**BOARD OF ZONING ADJUSTMENT
STAFF REPORT****Date: October 5, 2015****CASE NUMBER**

6006/5953

Jerry Arnold (Don Williams, Agent)

LOCATION103 North Warren Street
(Northwest corner of North Warren Street and St. Michael Street)**VARIANCE REQUEST****BULK SITE:** Bulk Site Variances to allow a 1,092 square foot courtyard with a metal canopy supported by columns, a 3' high fence, and less than 20% transparency for frontage walls in a SD-WH Sub-District in the Downtown Development District.**ZONING ORDINANCE
REQUIREMENT****BULK SITE:** The Zoning Ordinance allows courtyards no larger than 600 square feet with metal canopies supported from the building, no fences, and a minimum of 20% transparency walls for a pedestrian forecourt frontage in a SD-WH Sub-District in the Downtown Development District.**ZONING**

SITE PLAN

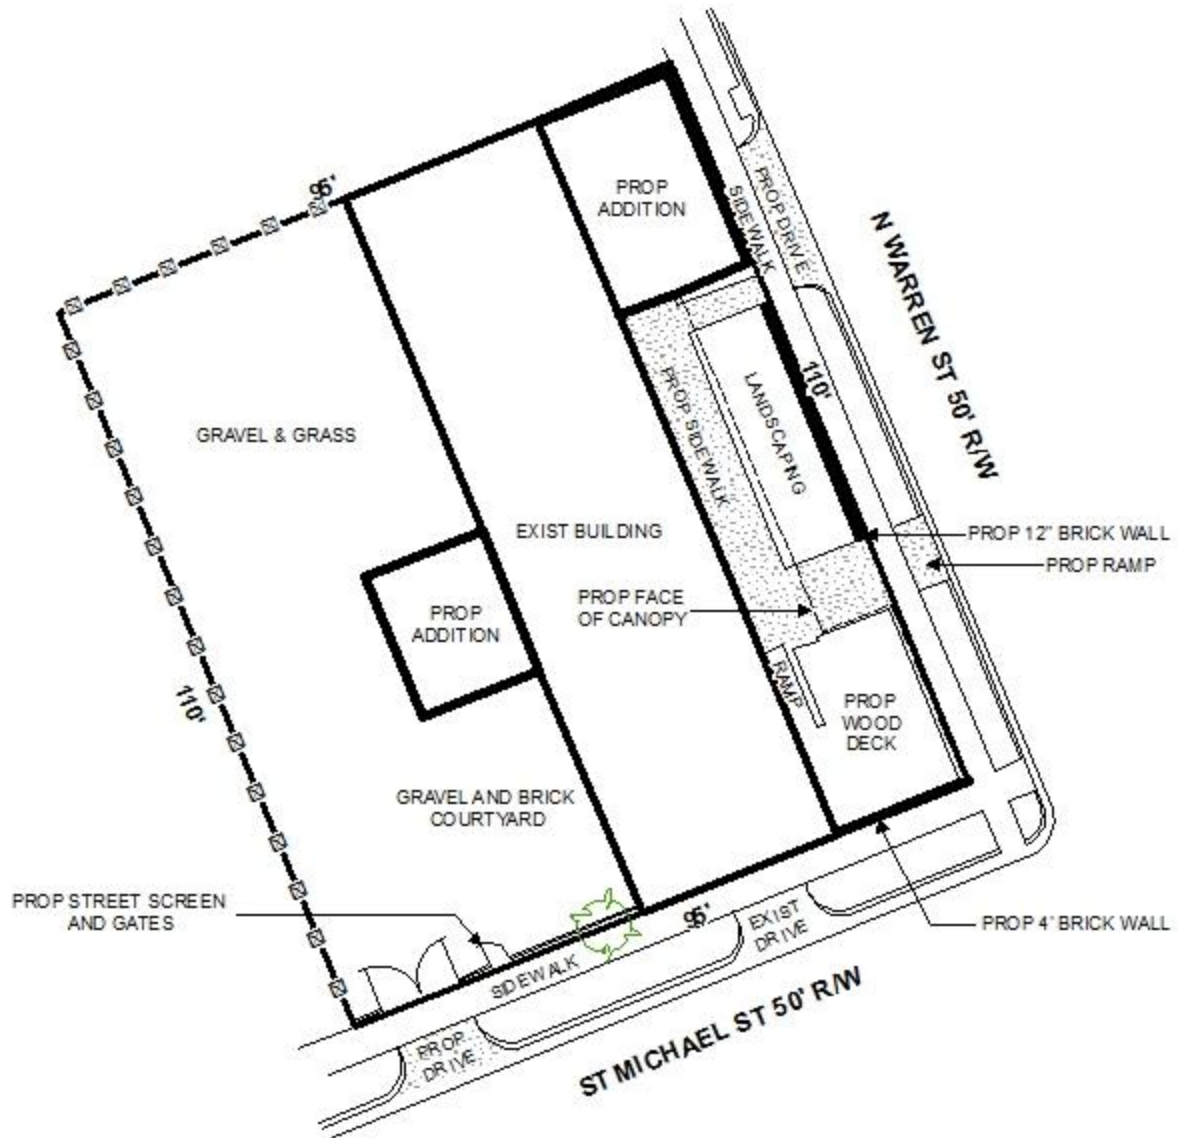
The applicant wishes to construct a 20' x 30' addition to the existing structure along the North Warren Street frontage to serve as a cooler for a proposed brewery. The placement of this addition will create an entry courtyard that is approximately 1,092 square feet, while the Downtown Development District does not allow entry courtyards to exceed 600 square feet. The applicant could easily increase the size of either the newly proposed cooler addition or the proposed wooden deck (which could also be considered a porch) in order to decrease the size of the courtyard to comply with the regulations.

Similar to the previous variance request, the applicant wishes to provide a metal canopy supported by columns. Pedestrian forecourts allow either fabric awnings or metal canopies; however both must be cantilevered or otherwise supported by a building. The applicant states that if the proposed canopy were cantilevered or supported from the building, it would not meet building code wind load requirements. An almost identical request was approved by the Board for the site in May; therefore it may be appropriate to allow the canopy to be supported in such a way that it is compliant with building code requirements and reduces risks to the safety and welfare of future patrons.

In order to provide a visual separation of the proposed courtyard with the right-of-way, the applicant proposes to install a 3-foot tall fence composed of a 12" brick base, with a 24" wrought-iron topping. Fences are addressed in other frontages, but not in pedestrian forecourts, and are therefore not allowed.

The proposed cooler addition along North Warren Street is required to have a minimum transparency of 20%. Because of the insulated nature of the proposed addition, providing

windows may not be practical, and therefore it may be appropriate to waive the transparency requirement.

- 1) Obtain approval from the Consolidated Review Committee;
- 2) Obtain all necessary building and land disturbance permits; and
- 3) Full compliance with all other municipal and ordinances.
